**CULTURAL RESOURCES OFFICE
 PRESERVATION BOARD
 REGULAR MEETING
 MONDAY JANUARY 26, 2015 — 4:00 P.M.
 1520 MARKET ST. #2000
 ST. LOUIS, MISSOURI 63103
www.stlouis-mo.gov/cultural-resources**

DATE: January 26, 2015
 SUBJECT: Preliminary Review to construct a new classroom building
 ADDRESSES: 3972 Shaw Boulevard
 JURISDICTION: Shaw Neighborhood Certified Local Historic District — Ward 8
 STAFF: Bob Bettis, Preservation Planner, Cultural Resources Office

DATE: January 26, 2015
ADDRESS: 2739 Allen Avenue
ITEM: Preliminary Review to construct an addition
JURISDICTION: Fox Park Certified Local Historic District — Ward 6
STAFF: Bob Bettis, Cultural Resources Office

DATE: January 26, 2015
ADDRESS: 1219 Dolman Street
ITEM: Preliminary Review: Second submission, new construction, single-family house
JURISDICTION: Lafayette Square Certified Local Historic District — Ward 6
STAFF: Jan Cameron, Cultural Resources Office

SITE PLAN

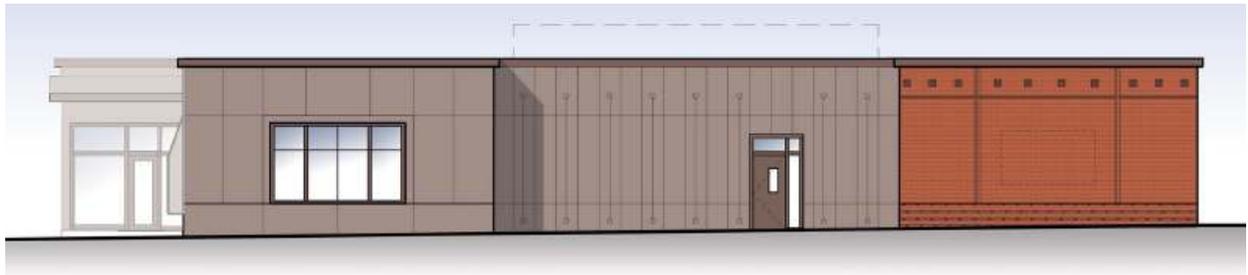
Does not comply. The proposed building is one story. The scale of the proposed building reflects the programmatic needs of the school. The overall design is compatible with the area and does not stand out or detract from the overall streetscape of Shaw Blvd.

Complies. All portions of the building visible from the street will be clad in red brick.

Complies. The building's fenestration pattern and brick detailing are based on the original historic school building. In addition, the building has a cornice-like element that is a reference to the terra-cotta and metal cornices seen throughout the Shaw neighborhood.

Complies. The building will have a flat roof.

PROPOSED SITE PLAN WITH SIDE YARD ADDITION

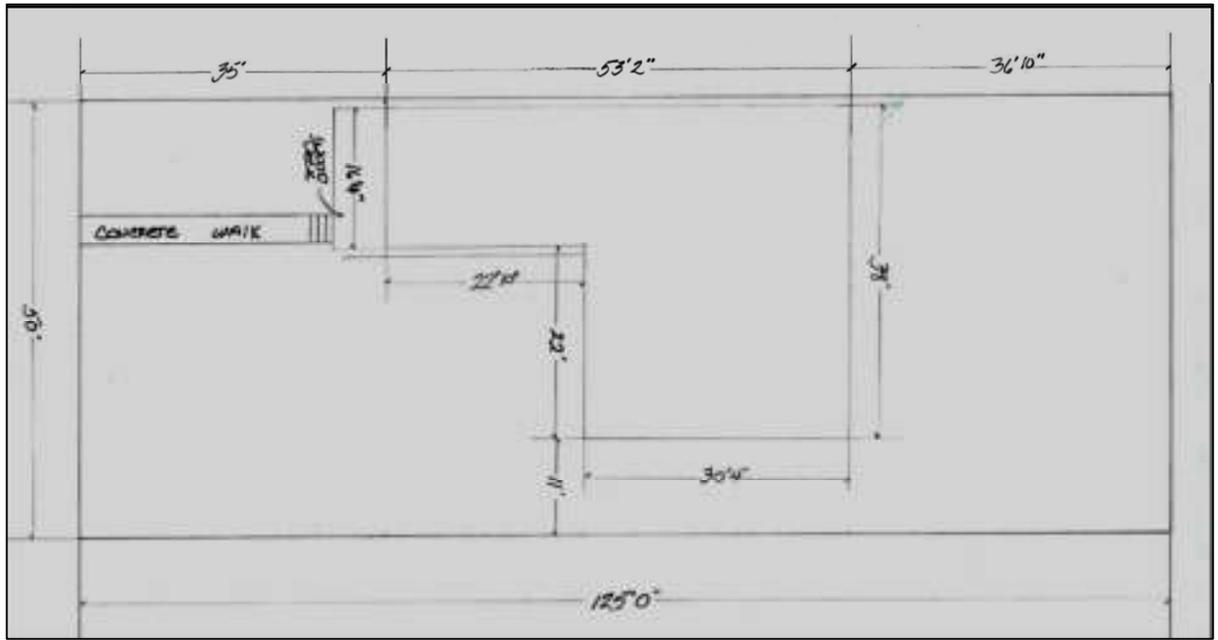
Does not comply. The proposed addition would extend from the rear of a Semi-Public façade.

Does not comply. The proposed addition is not based on a Model Example. There are few other existing frame buildings extant within the Fox Park district. Finding a suitable Model Example will be a challenge, given the age, size and site issues associated with this project.

The proposed addition would be at the rear of the Semi-Public façade and to the rear of the existing building. It would not establish a new alignment or setback if perceived as an addition.

Complies in height. The addition would have a roof ridge that is the same height of that of the existing building. The scale of the footprint of the addition is minimized by its location in terms of the house and its location on the lot.

Complies. The proposed addition will have 4" wood or Hardie Board lap siding similar to that of the original house.

REVISED ELEVATION

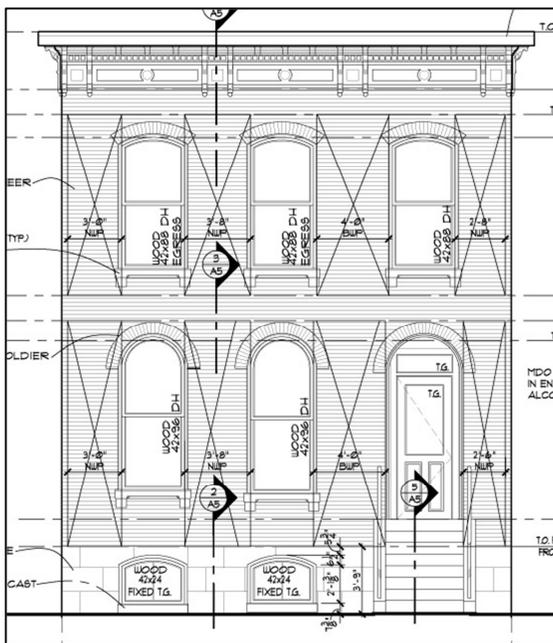
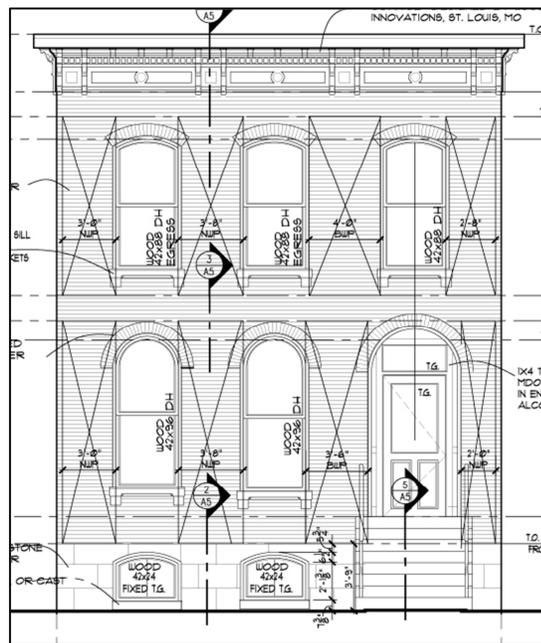
The applicant is proposing to use the same HME previously used in several locations in the Square and the Cultural Resources Office has approved it as an appropriate HME. Revisions to the original submission have now followed the HME more closely.

One change agreed to by the owner that is not reflected in the revised drawings is that the front foundation will be veneered with rusticated stone in place of the simulated stone originally proposed.

Complies. Revisions have been made to the recessed entry to more closely follow the HME.

SITE PLAN SHOWING APPROXIMATE LOCATION OF SIGN

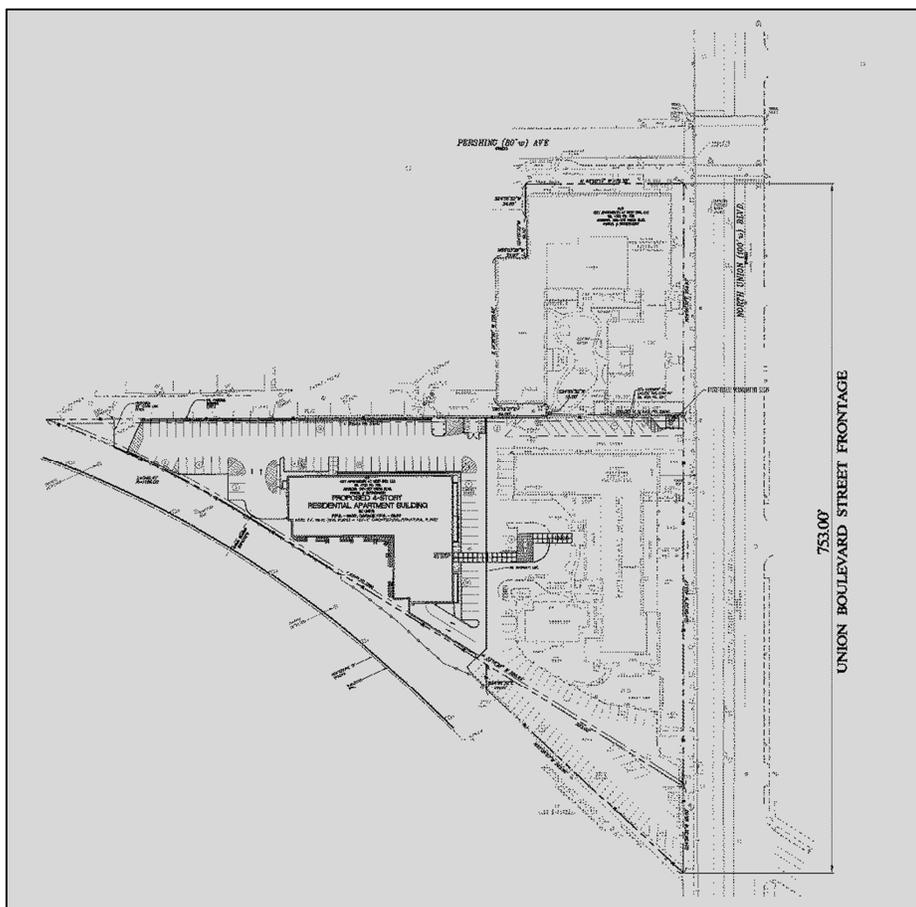
Complies. The sign will be the only monument sign for the complex, which includes four large apartment buildings.

- The design of the sign is intended to coordinate with the contemporary signs placed at each building entry, which are cut stainless steel letters in an Art Deco font.
- The CWE standards do not address the materials or the design of commercial signs. The proposed sign will be stainless steel and white acrylic with edge-lit letters.
- The proposed height of 16 feet is considerably taller than allowed by zoning and the sign would have the effect of towering over pedestrians. A maximum height of 10 feet would be more in scale with the pedestrian realm but provide visibility.
- While the sign is large, the complex has approximately 700 feet of street frontage. This will be the only monument sign to identify four large multi-story apartment buildings.
